DART AEROSPACE LTD HAWKESBURY, ONTARIO, CANADA	
DRAWING NO. D206-667-247	REV. A SHEET 1 OF 4
TITLE CROSSTUBE ASS'Y (206L MID AFT)	SCALE NTS

DRAWING NO. D206-667-247	TITLE CROSSTUBE ASS'Y. (206L MID AFT)	REV. A	DART AEROSPACE LTD ENGINEERING ORDER		D.E.O. NO. D206-667-247-A-1	SHEET NO. SHEET 1 OF 1	SCALE NTS
DRAWN 9	CHECKED ASS	MFG. APPR. KJ	APPROVED JMP		DE APPR. #		
DATE 11.07.15	DATE 11.07.20	DATE 11.07.21	DATE 11/07/21		DATE 11.07.21

PURPOSE:

REPLACE MAGNOBOND WITH PROSEAL.

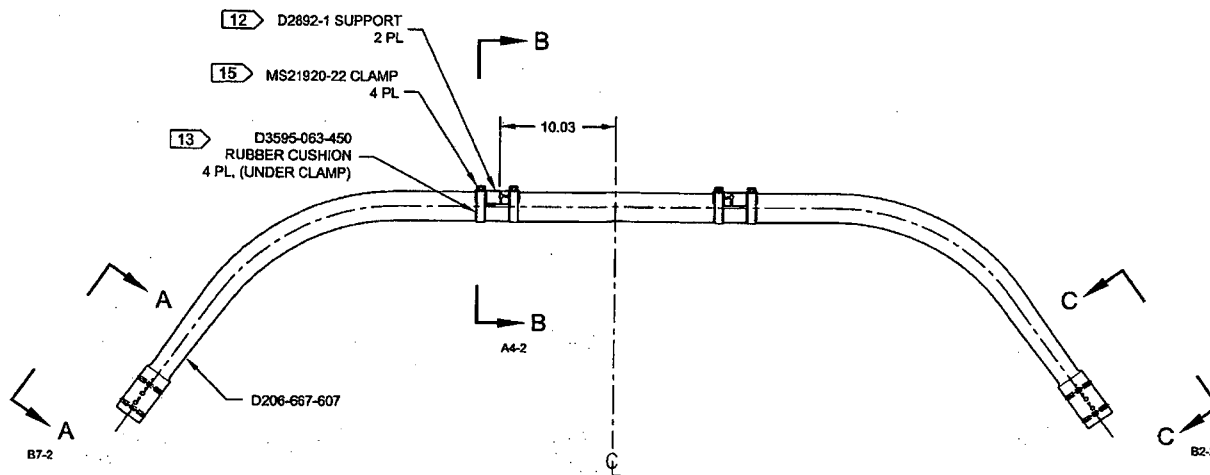
IS:

Item	Qty -247	Part Number	Description
9	A/R	PROSEAL 890 B-2	SEALANT, AMS-S-8802 CLASS B-2

WAS:

9	A/R	MAGNOBOND 6398	ROCKWELL SPECIFICATION RBO-120-023 ADHESIVE (TEXTRON/BELL SPEC. 299-947-100, TYPE II, CLASS 2 ADHESIVE)
---	-----	----------------	---

NOTE 12 & 15, SHEET 1 IS AMENDED AS FOLLOWS:

IS:

- 12) TO INSTALL D2892-1 SUPPORT: ABRASE MATING SURFACE OF SUPPORT AND CROSSTUBE WITH 180-GRIT SANDPAPER AND REMOVE RESIDUE WITH MEK (OR EQUIVALENT). APPLY A 0.04" TO 0.07" THICK LAYER OF PROSEAL 890 CLASS B-2 (OR AMS-S-8802 CLASS B-2) SEALANT TO MATING SURFACE OF SUPPORT.
- 15) TORQUE CLAMPS 80 TO 100 IN-LB. ENSURE AT LEAST 1.5 THREADS SHOWING IN SAFETY AND THAT NUT HAS NOT BOTTOMED-OUT AFTER TORQUING. **PRIOR TO PACKAGING, RE-CHECK TORQUE ON CLAMPS AFTER PROSEAL 890 SEALANT HAS CURED FOR 72 HOURS.**

WAS:

- 12) INSTALL D2892-1 SUPPORT USING 0.03" TO 0.06" THICK LAYER OF MAGNOBOND 6398 PER QSI 015. LET CURE FOR 12 HOURS AFTER INSTALLATION AND PRIOR TO PACKAGING.
- 15) TORQUE CLAMPS 80 TO 100 IN-LB. ENSURE AT LEAST 1.5 THREADS SHOWING IN SAFETY AND THAT NUT HAS NOT BOTTOMED-OUT AFTER TORQUING.
